| Converted from Eagle schematic; see README.md |       |          |
| Title: Sequencer-Logic-Prod-V2.1l             |       |          |

| <b>Title: Sequencer-Logic-Prod-V2.1l sheet 5</b>                      |       |          |

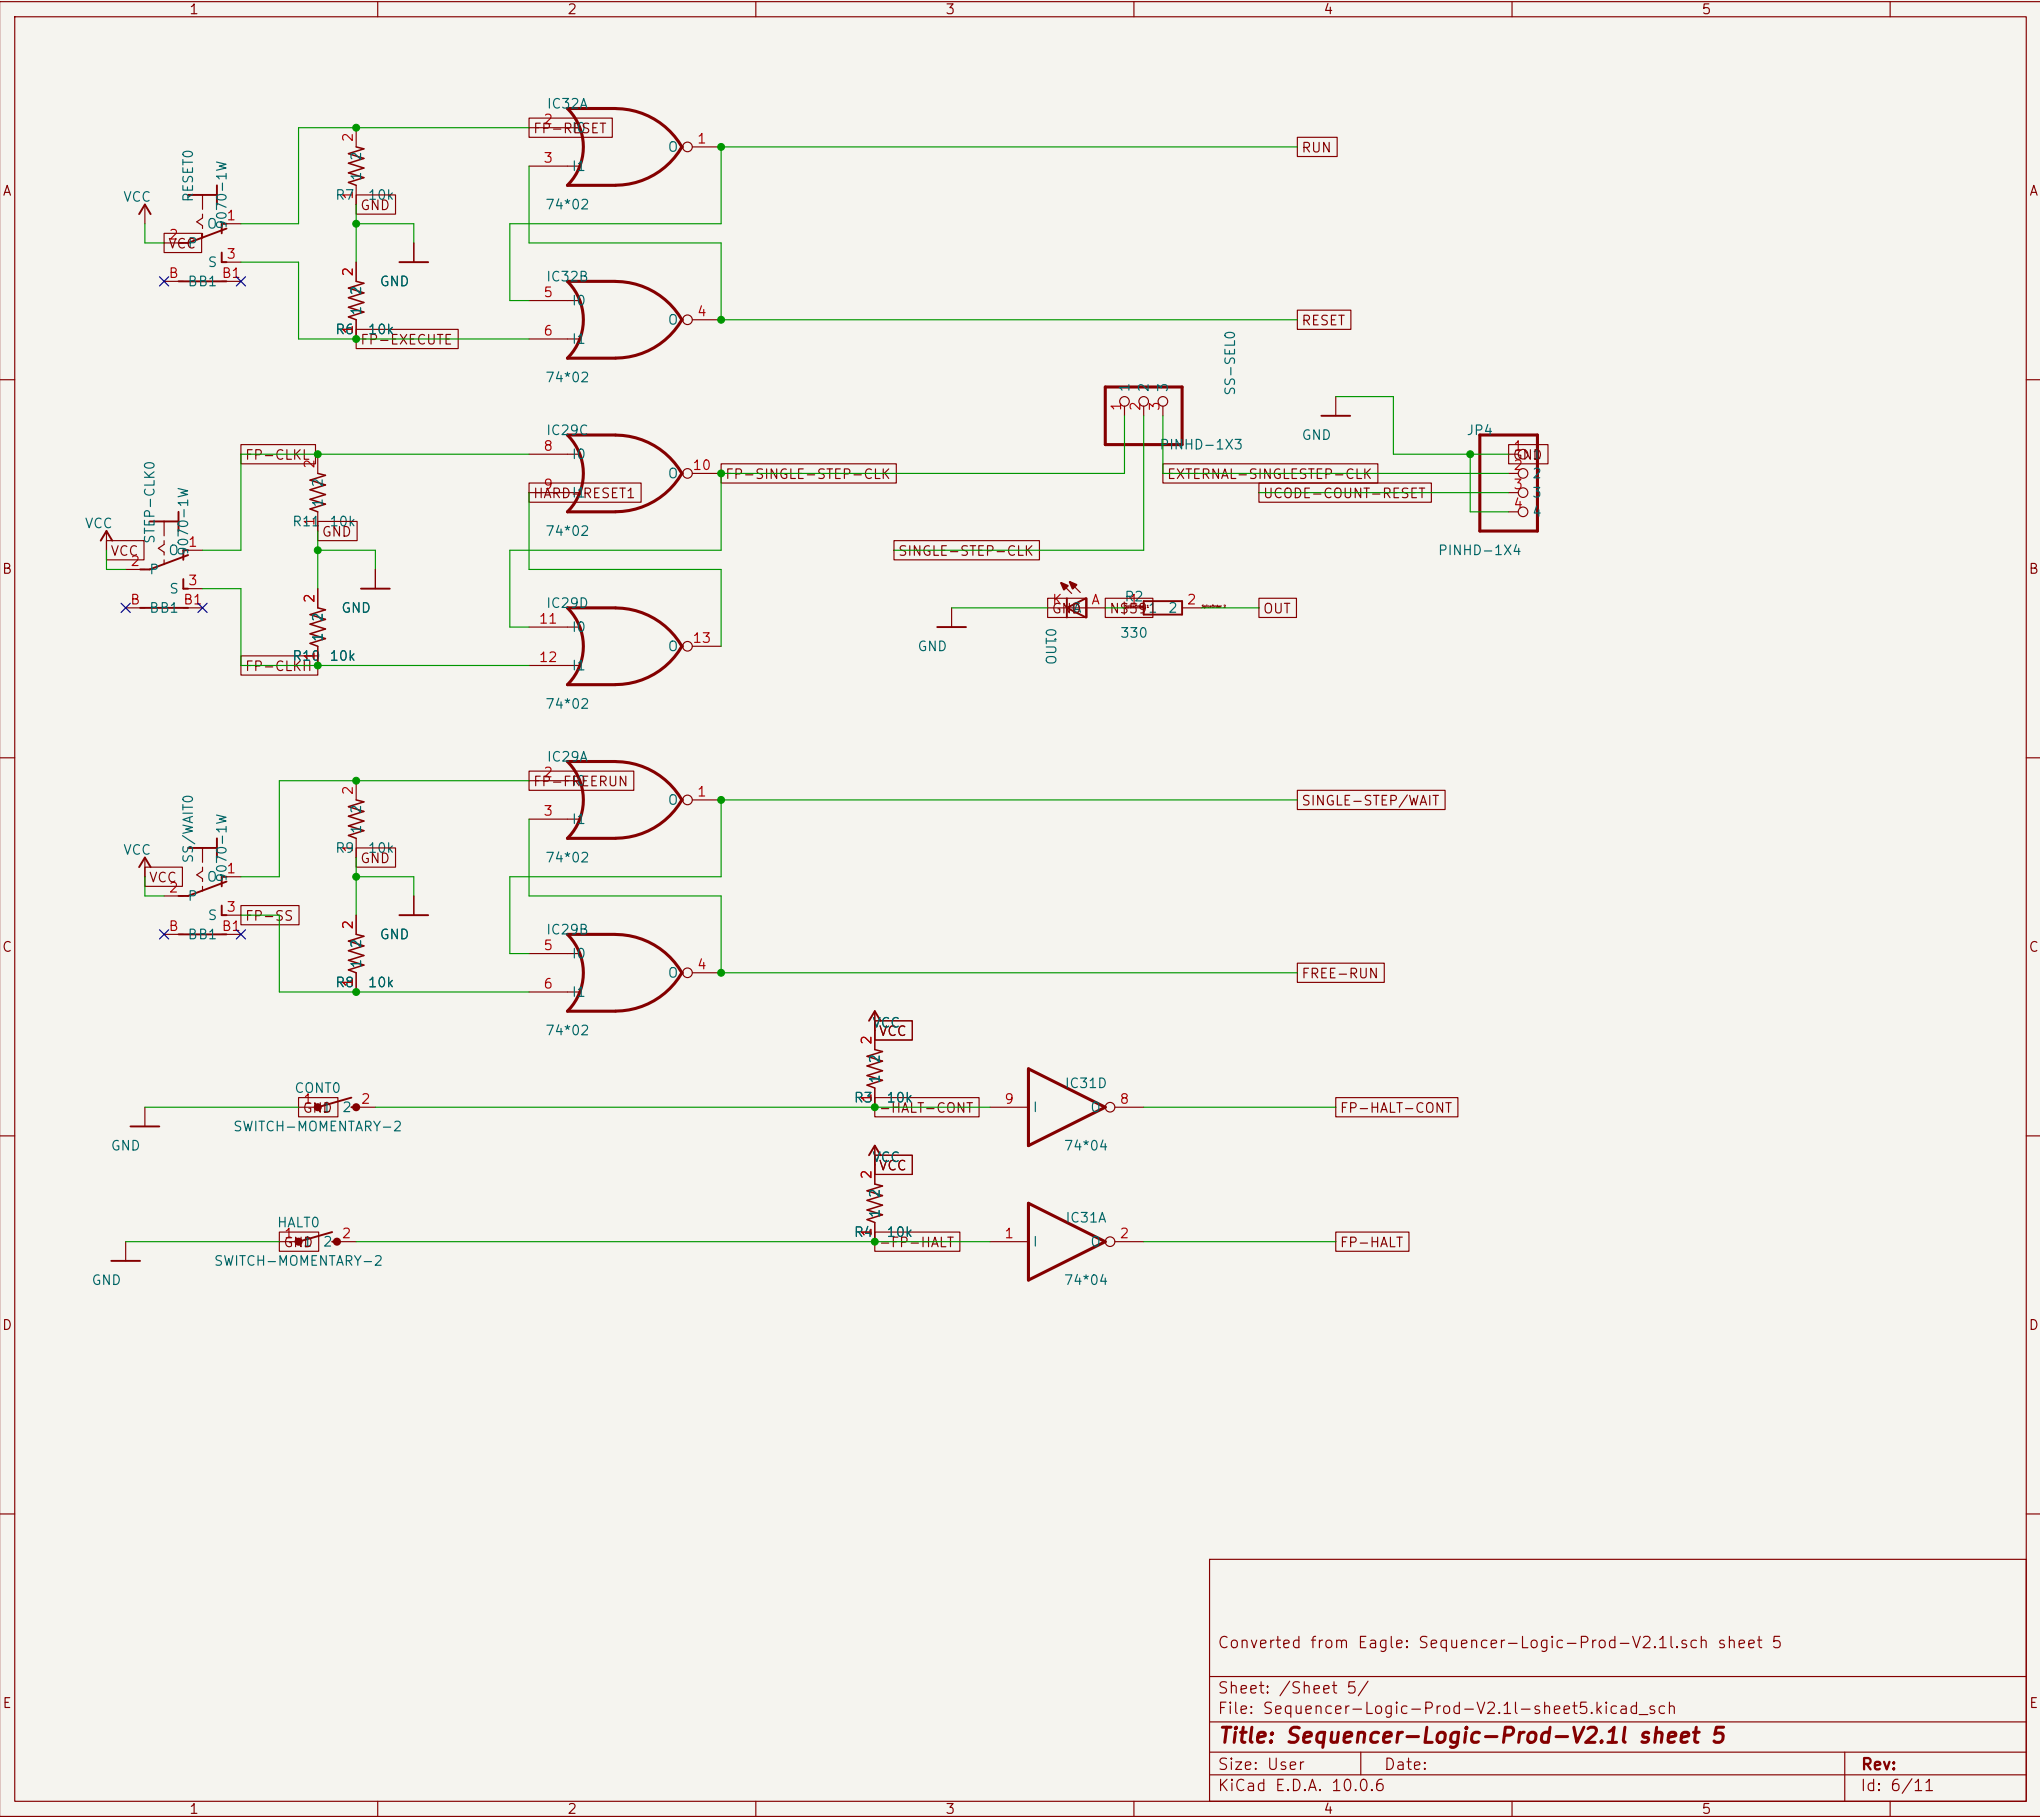
Should operand clk be part of mem-logic or generated signal

**Title: Sequencer-Logic-Prod-V2.1l sheet 6**

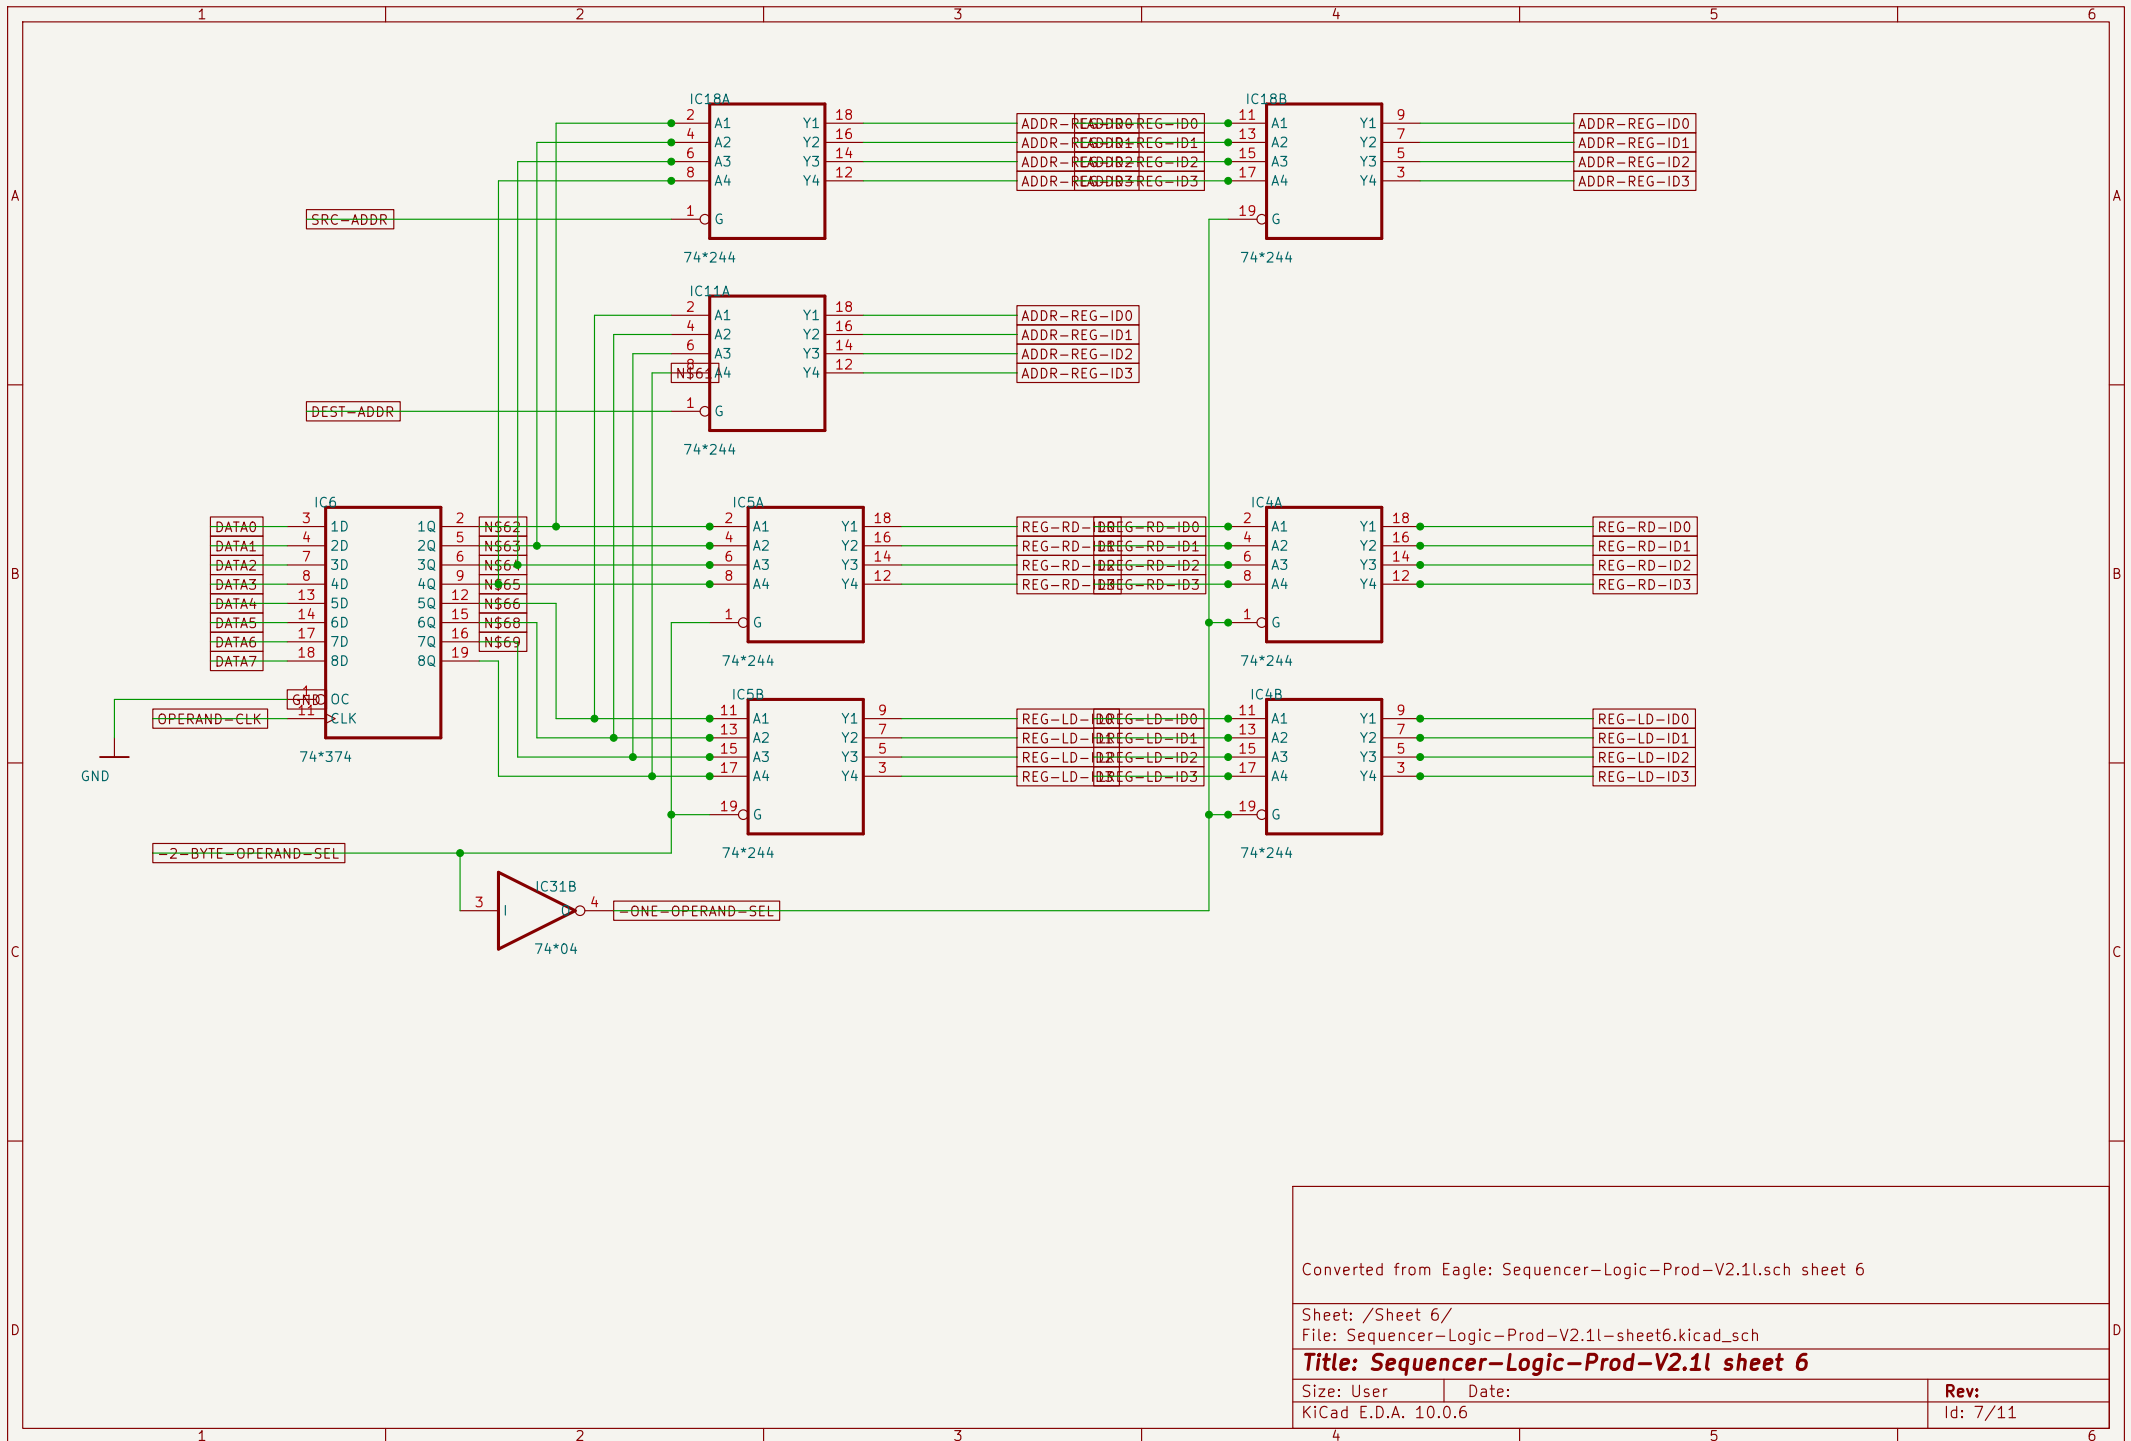
drive reg-rd/ld and ioaddr from separte signals and add to drive addr line driving
